**OLIVER WOLCOTT TECHNICAL HIGH SCHOOL
SOFTBALL FIELD ADDITION
TORRINGTON, CONNECTICUT
PROJECT: BI- RT - 855**

| ADDENDUM NUMBER 1 | DATE OF ADDENDUM | February 3, 2012 |

The following clarifications are applicable to drawings and specifications for the project referenced above.

| PROJECT NO. 07-15426 | | PROJECT NO. 07-15426 PROJECT NO. 07-15426 | | SK.01 10-F-1 |

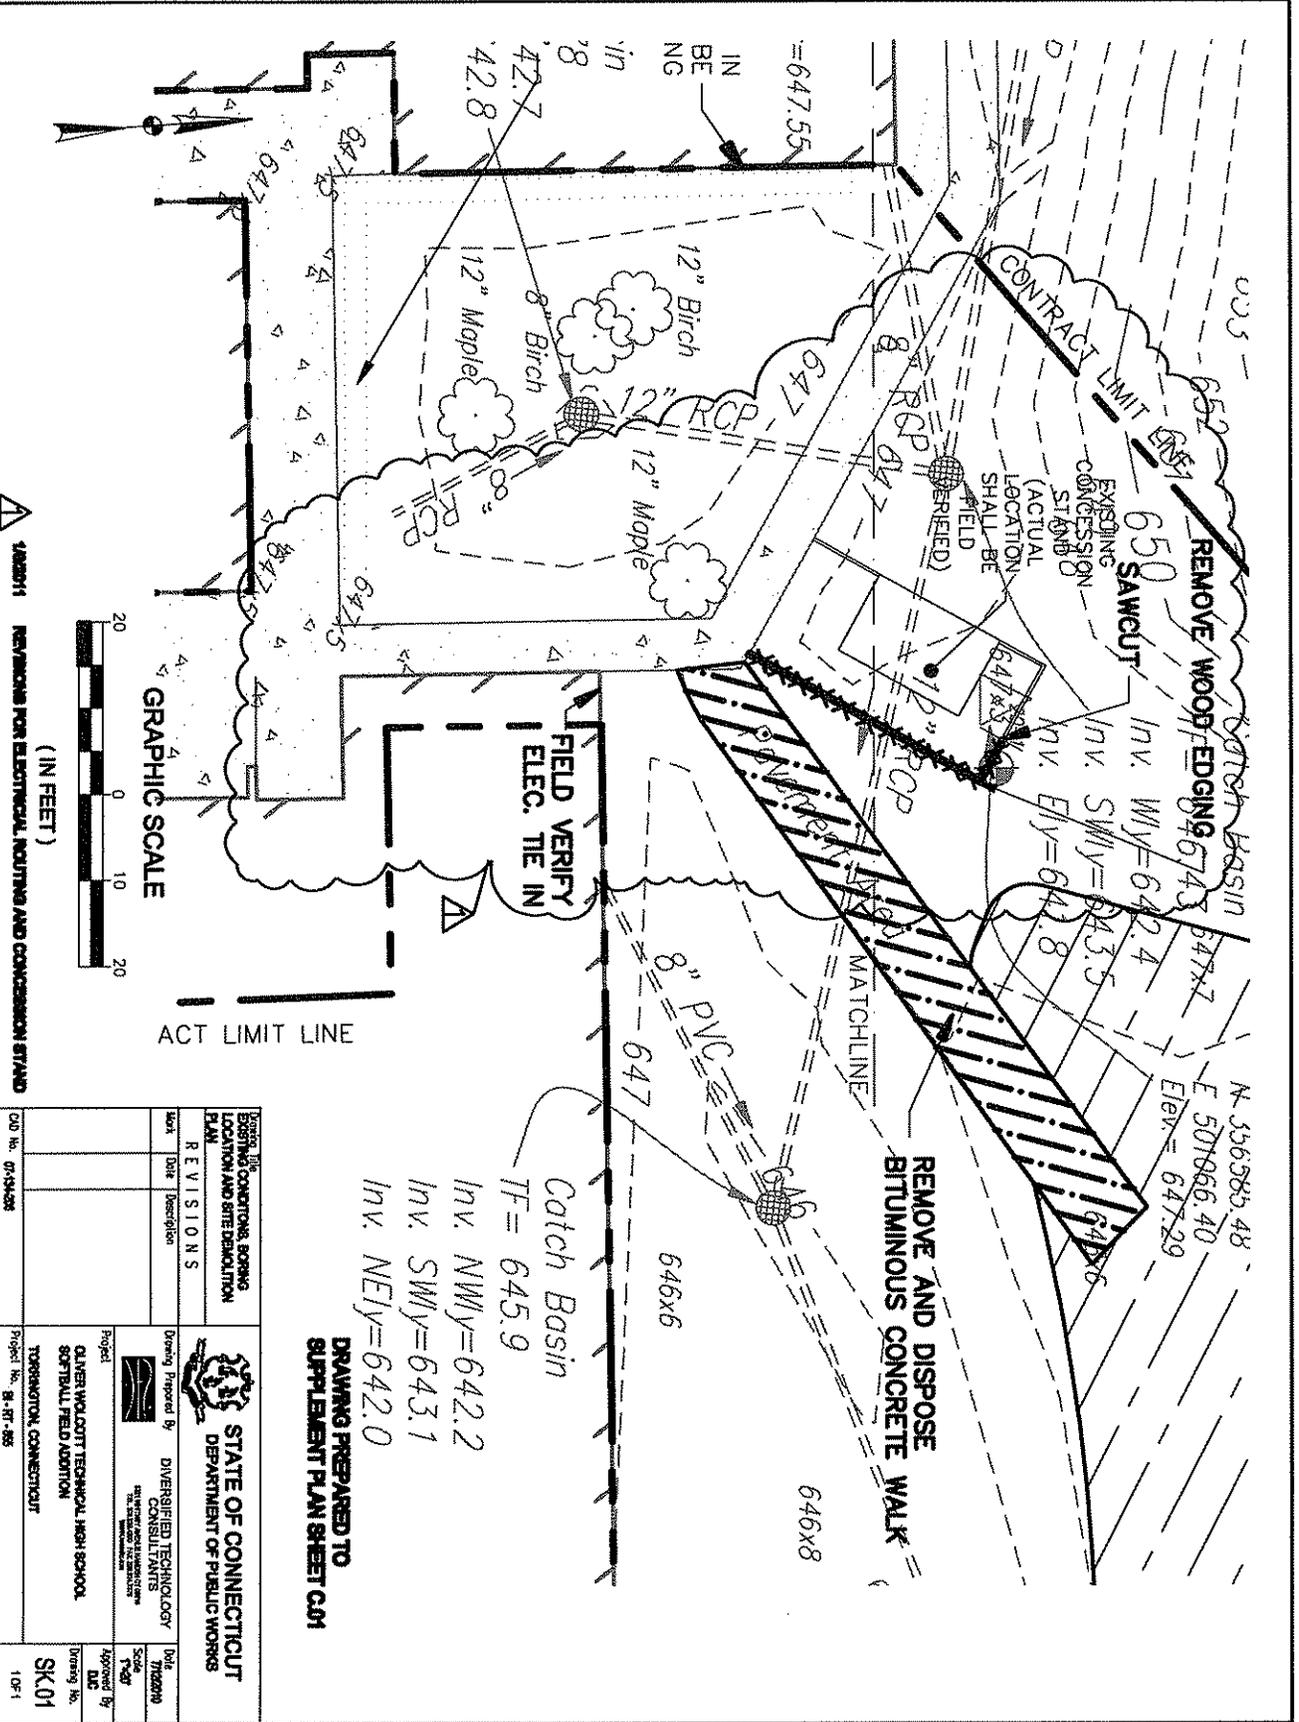
On Drawing No.C.01:

REVISE limits of walk removal in accordance with Drawing SK.01 herein attached. Existing concrete walk that was mislabeled as bituminous concrete walk will remain.

| C.D. No. 07-04-038 | | Project No. 8-177-063 | Drawing No. SK.02 1 OF 1 | |

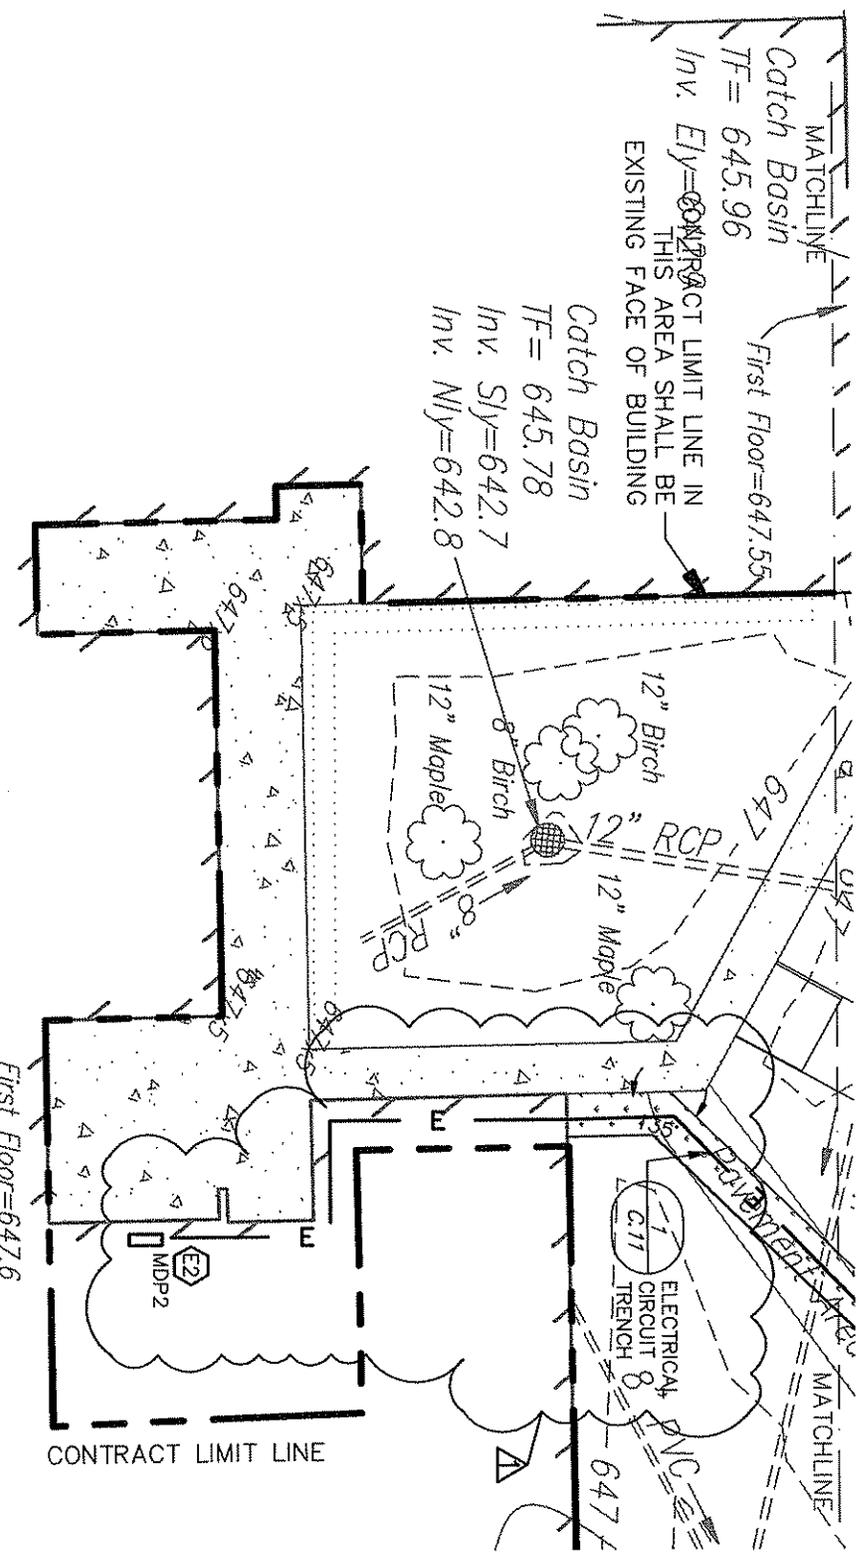
On Drawing No. C.05

REVISE location and construction of new sidewalk in accordance with Drawings SK.02.and SK.03 herein attached.

REVISE electrical service line routing to avoid existing concrete sidewalk in accordance with Drawings SK.02, SK.03,and SK.04 herein attached.

UNDERDRAIN CLEANOUT DETAIL

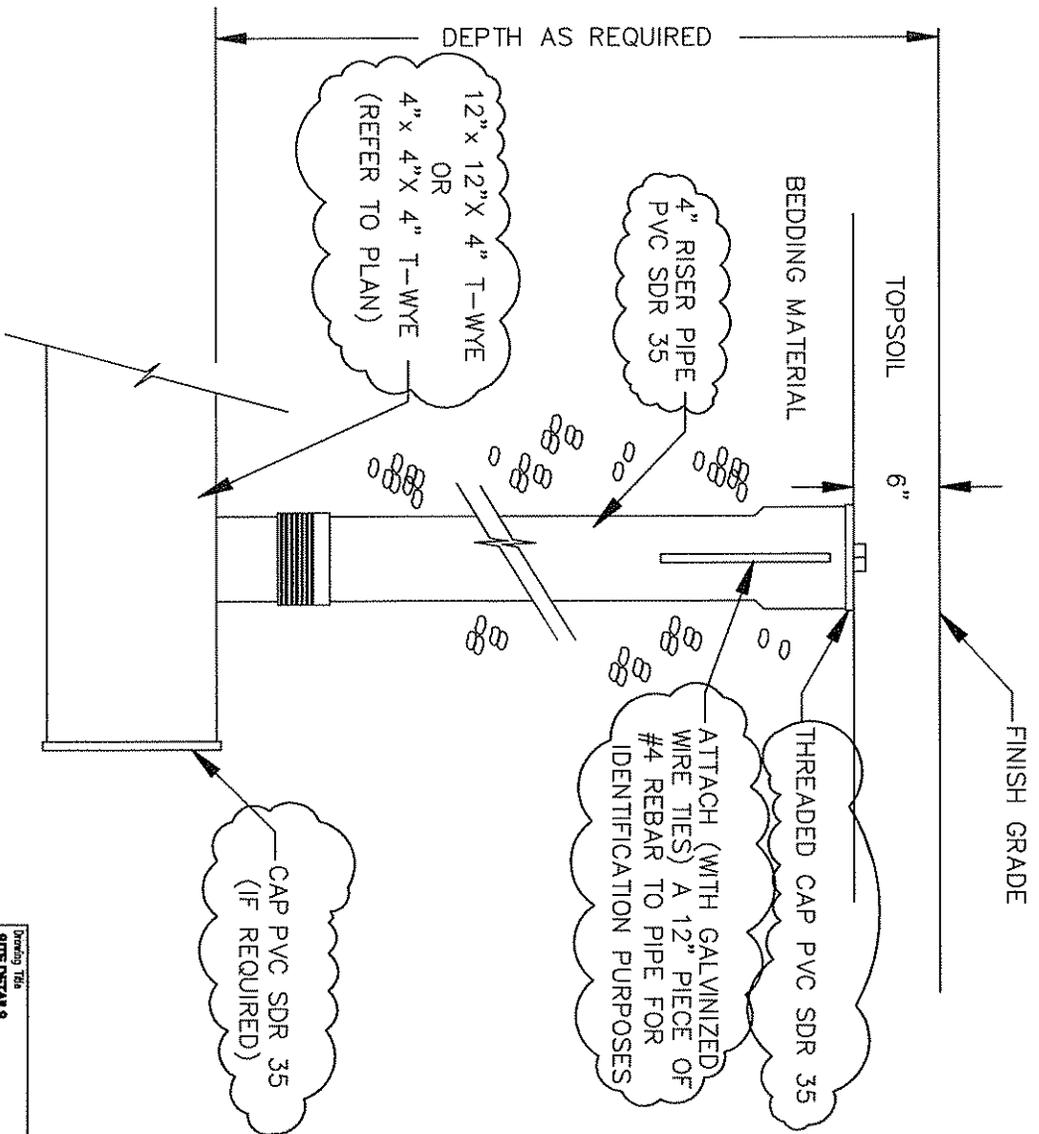
On Drawing No. C.09

REVISE Information adjustment made to Detail 5 in accordance with SK.05 herein attached.
